Subject: Duke Power Company LLC d/b/a Duke Energy Carolinas, LLC
Oconee Nuclear Site, Units 1, 2, and 3
Docket Numbers 50-269, 50-270, and 50-287
License Amendment Request for Allowing Use of Atmospheric Dump Valves to
Control Main Steam Pressure During a Standby Shutdown Facility Event (TSC 2006-
07)

Subject: License Amendment Request for Allowing Use of Atmospheric Dump Valves to Control Main Steam Pressure During a Standby Shutdown Facility Event

UFSAR Markup for operation of ADVs during an SSF Event

Tech Spec 3.7.4 Bases markup for operation of ADVs during an SSF Event

Figure 1
ATMOSPHERIC DUMP VALVE OPERATION

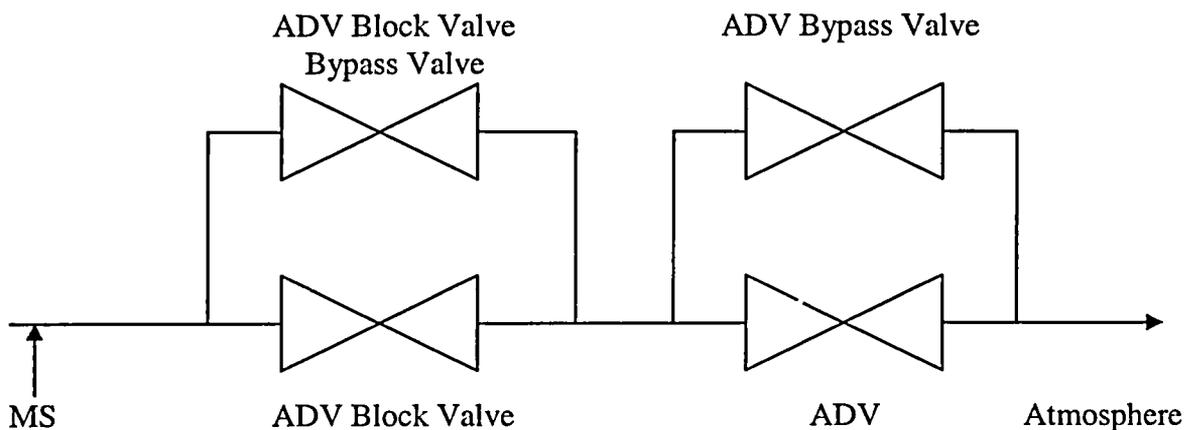
For each SG (reference Figure 1), the ADV flow path is comprised of the ADV block valve bypass valve, the ADV block valve, the ADV, and the ADV bypass valve. The ADV and the ADV bypass valve are in parallel and are located downstream of the ADV block valve. The ADV block valve bypass valve is opened first to equalize the differential pressure across the ADV block valve. When cooldown is to be conducted, the ADV block valve is opened, and the cooldown rate is controlled using the ADV.

The ADV bypass valve is not needed for controlling MS pressure to reduce MSRV

cycling. However, during an SSF Appendix R event, the ADV bypass valve may be used later in the event to provide additional flow above the flow rate provided through the ADV to allow plant cooldown.
